INDESIT company

Model type:
WIA101EX

Commercial code:
F034486

General notes

1180160B Exploded views

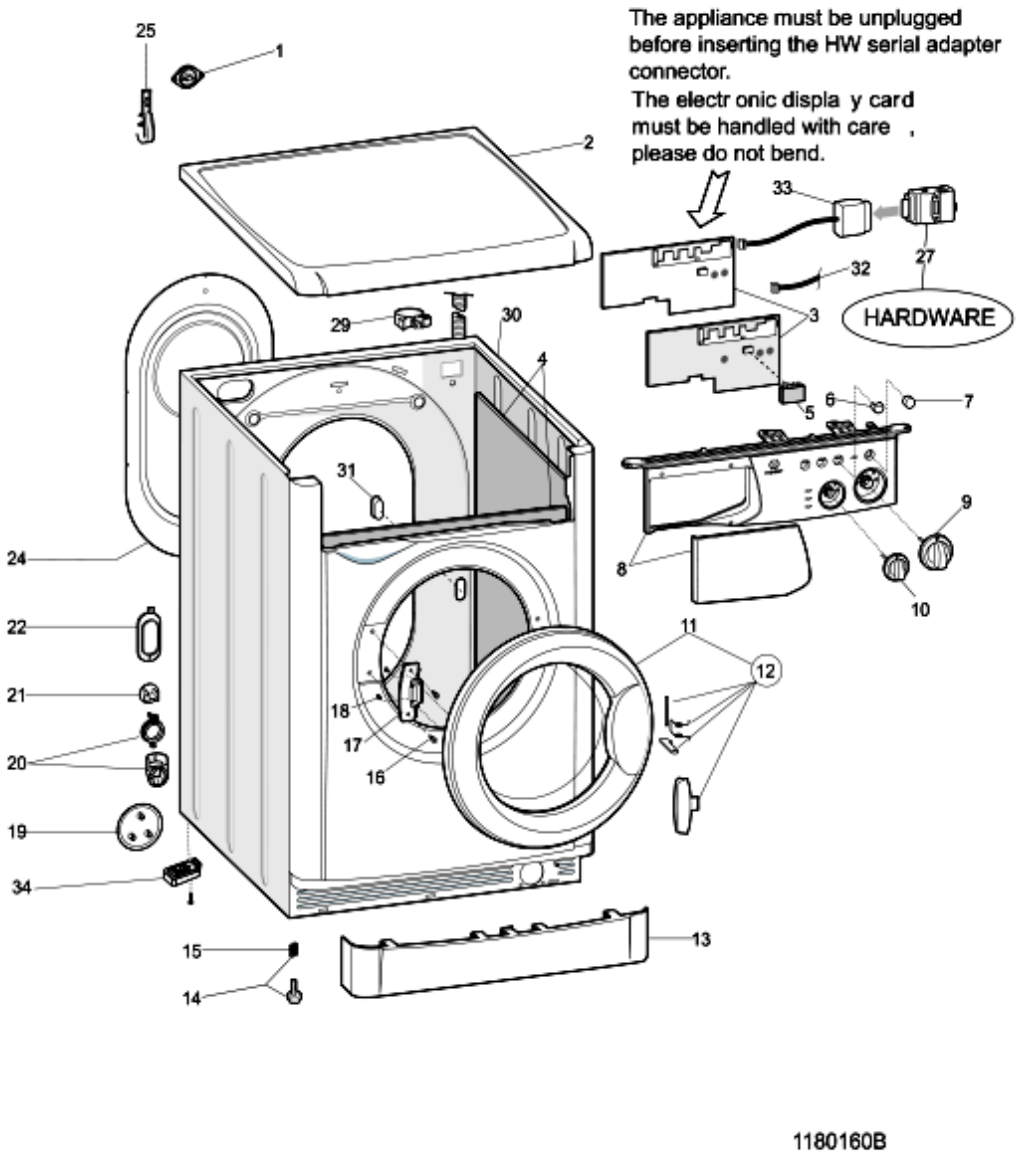
n4007j00: Rear feet changed

From Serial Number 70403.0001 the two rear feet changed with new code C00254045, the cabinet fixing has been modified.

The new feet are not interchangeable with premodification.

CABINET
The spare part code isn't changed, in the warehouse stock we have the new cabinet.
If you fix it on premodification models you need to use the new feet.

1180250 Exploded views

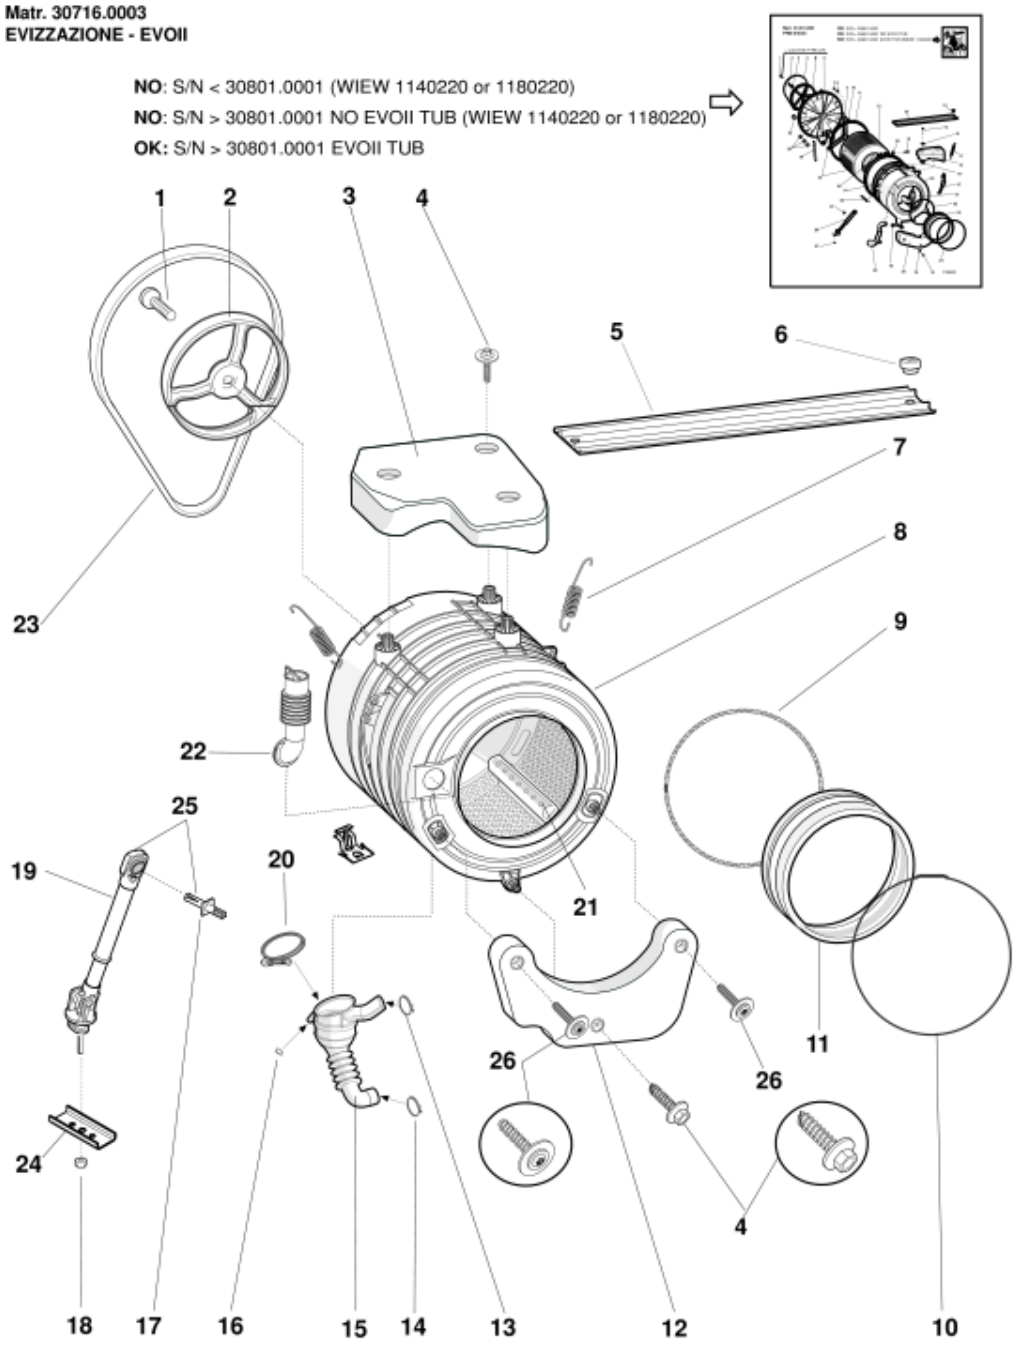
n1040372: Introduction of new shock absorbers and expanders.

From serial no. 50725.0001, new shock absorbers and expanders have been introduced.

New codes:
C00140670 - shock absorber
C00118593 - expander

Premodification codes
C00097259 - shock absorber
C00055037 - expander

The new items can also be used (but not separately) when replacing shock absorber 100N - C00097259; in this case, it will be necessary to replace both shock absorbers / expanders using kit C00140744, which is composed of two new shock absorbers and two new expanders.
